Item #12  
MCPB  
09.11.03

**MEMORANDUM**

**REVIEW TYPE:** Project Plan  
**CASE NUMBER:** 9-03002  
**PROJECT NAME:** Woodmont Corner  
**APPLYING FOR:** Approval of: 284,185 sf of Development, including  
18,808 sf Retail Space  
253 High Rise Residential Units  
including 44 MPDUs of which 32 are MPDUs provided on Site  
250 Parking Spaces

**Figure 3, Building and road frontages for Woodmont Corner. The red area shows the Woodmont Avenue ROW proposed for purchase and immediate re-dedication.**

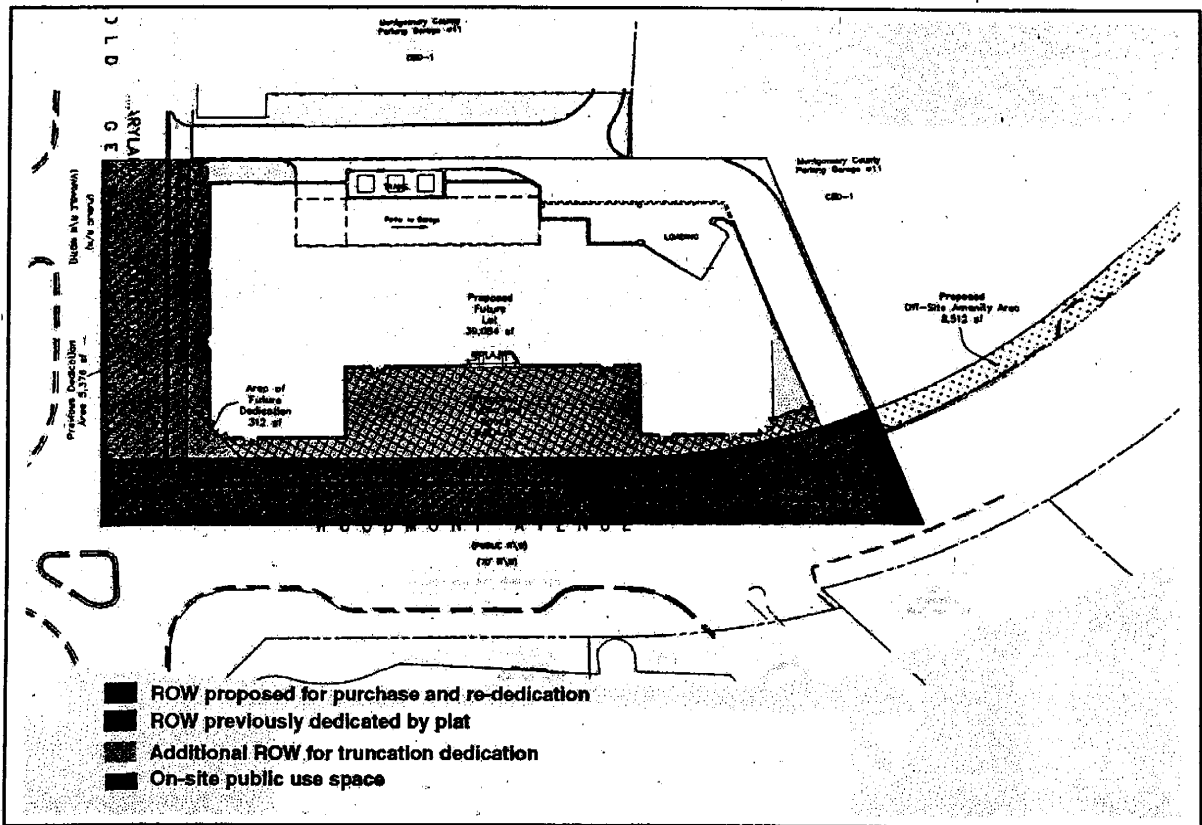
This issue of review will be presented to the Planning Board for consideration as a Mandatory Referral concurrent with hearings for this Project Plan and the Preliminary Plan. The issue of interest is the applicant's request to purchase from Montgomery County 12,065 sf of right-of-way land area that adjoins the sidewalk adjacent to Woodmont Avenue along the subject property's frontage.

The applicant has proposed to the County that 33% of the unit density gained through the application of the additional floor area be provided as MPDUs. The applicant's correspondence with the Office of the County Executive indicates approval by the County Executive, subject to the provision of the additional 33% MPDUs and the payment representing the present value of the land (\$269,000). [See letter from Lisa Rother, Office of the County Executive, dated January 17, 2003, attached.]

STAFF POSITION: Staff supports the applicant's proposal to incorporate the "recovered" 12,065 sf as part of the gross tract area because the additional density and the total number of dwelling units provided are compatible with the desired CBD development. More significantly, the provision of this incremental density will accommodate additional residential units, of which the applicant proposes that 33% of the 57 gained units will be designated for the MPDU Program.

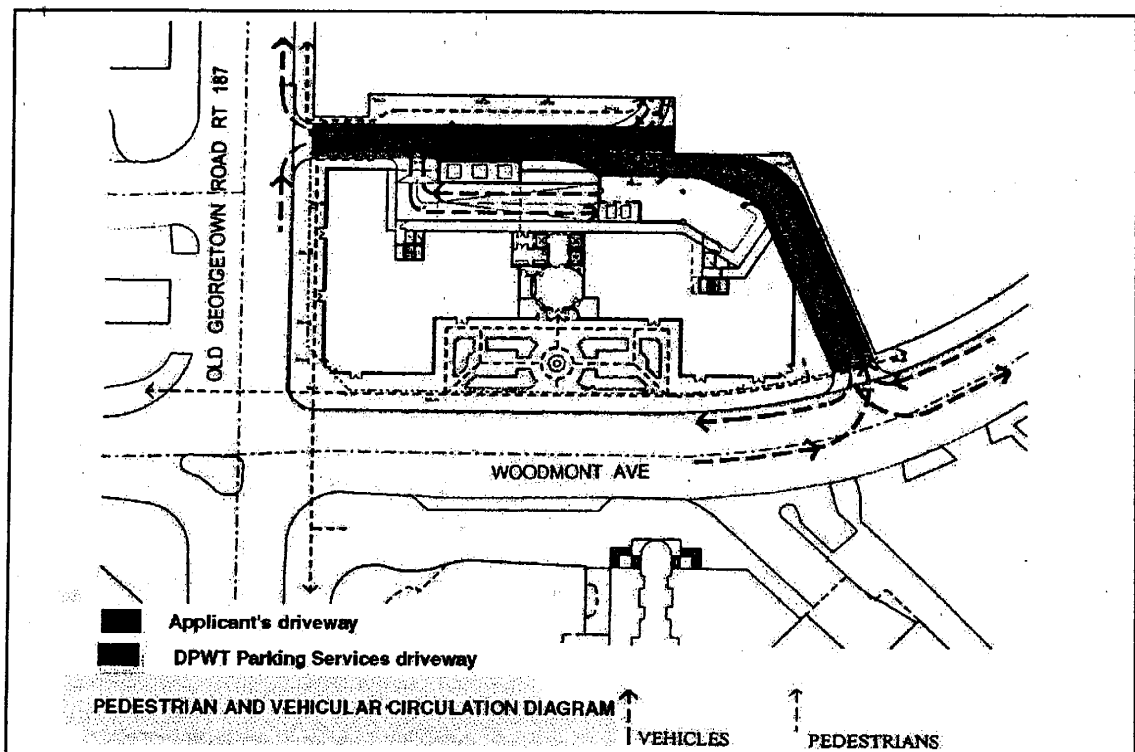
The applicant's proposal features vehicular access from Old George Road to the underground parking via shared use of an access way that services County Public Garage #11, owned by the DPWT Traffic and Parking Services (TPS) Division. Site design also features a private, supplemental driveway connection located within the applicant's property, which would wrap the building on the north, with an entry point from Woodmont Avenue. The applicant proposes a reciprocal easement agreement granting access to both parties and the general public for use of both vehicular accesses drives. This solution would provide two-way traffic around the rear of the new building with ingress and egress from Old Georgetown Road and Woodmont Avenue – resulting in greater vehicular and pedestrian efficiency and safety.

**COUNTY POSITION:** The two DPWT Divisions have performed a substantial review of the traffic plan and infrastructure design. TPS has determined that use of the applicant's connecting driveway will offer an identifiable benefit to users of the public garages. Both DPWT divisions have provided letters of approval for the easements, subject to execution of the agreements with extensive conditions. [See also letters of correspondence, Attachments # .]

**STAFF POSITION:** Staff supports the applicant's proposal. Vehicular use of the two driveways will provide superior circulation for both automobiles and pedestrians, with increased efficiency and safety with a higher quality of streetscape in the CBD. [See also *Findings*, page 27.]

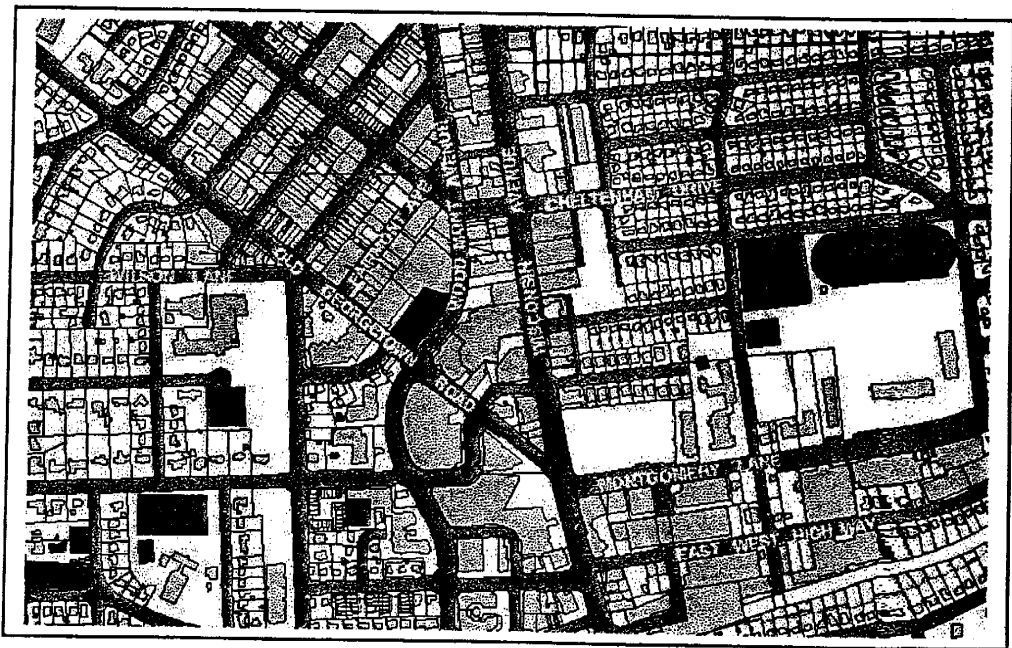
The plan proposes to remove two or three of the existing on-street metered parking spaces along the west side of Woodmont Avenue in order to provide a signed, curbside vehicular drop off area for the proposed apartment building. This arrangement would require the applicant to lease or purchase the two parking spaces from the DPWT Parking Services Division.

**COUNTY POSITION:** The DPWT Division of Parking Services and the Division Operations recognizes the desirability of the proposed curb side drop off area that does not interfere with pedestrian safety or traffic flow. The arrangement is subject to further review and approval by the two divisions.

**STAFF POSITION:** Staff supports the applicant's proposal and encourages this design alternative that allows the full Bethesda Streetscape with wide sidewalks, safer pedestrian movement, and more efficient southbound traffic flow on Woodmont Avenue.
